The People's Republic of Bangladesh
Dhaka Water Supply and Sewerage Authority (DWASA)
Dhaka Sanitation Improvement Project (DSIP)
IDA Credit Number: 6566-BD/AIIB Loan No.: L0240A

Corrigendum Notice-1

Subject: Minutes of Pre-Proposal meeting for Design, Build Contract for Reconstruction /New Construction/Rehabilitation of Sewerage Networks for Zone W1 & W2 (Kalabagan, Mogbazar, Shahbag, Eskaton, etc.) (Package No.: WD5A) held on 14 December, 2022 under Dhaka Sanitation Improvement Project (DSIP), Dhaka WASA.

Response Matrix-1

Aggregate length of sewer collection network between DN200 and DN1100, Vol.4-CDR

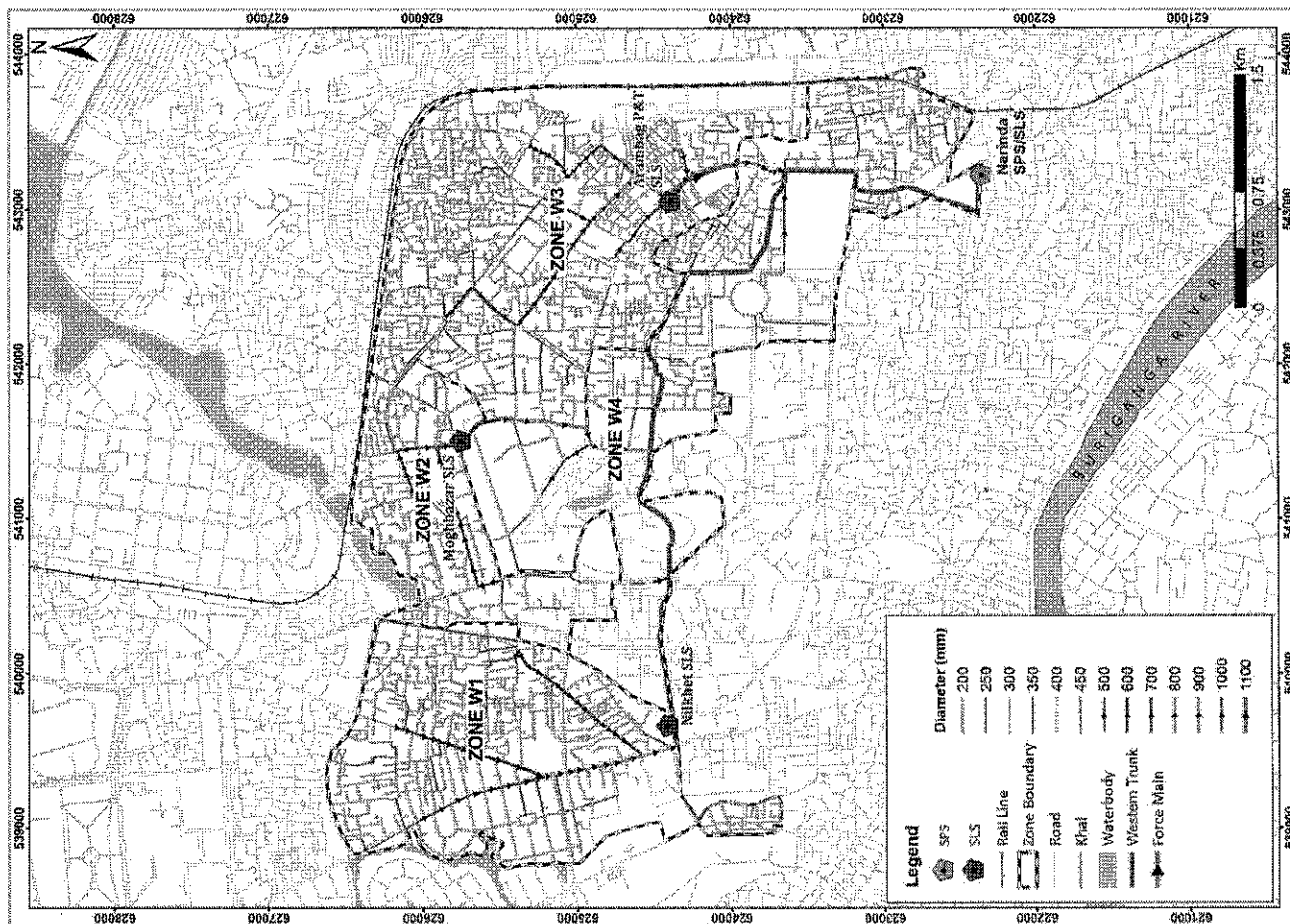
Sl. No.	Clause, Section & Page No.	RFP Specifications	Query	Reply
8.	Volume 4-CDR, Table 29		In accordance with the Table 29. Overall Summary of Sewage Collection Network (Length and Depth) in Volume 4-CDR, it has shown the aggregate length of sewer collection network between DN200 and DN1100, we hereby humbly request your authority to provide the separate length of sewage collection network of WD5A Package. (Please see Table 29 attached herewith - Annexure-1)	Conceptual Design is only for the reference. The Contractor shall carry out the detailed design during the implementation stage. Please refer to the drawing and Employer's requirement for the details of sewer networks. The information of the relevant sewerage collection network is available in the concern part of the Employers requirement. i.e. a) Supplementary information, b) Conceptual design and drawing. Anyway, the detail is annexed herewith as a reference (Annexure-2).
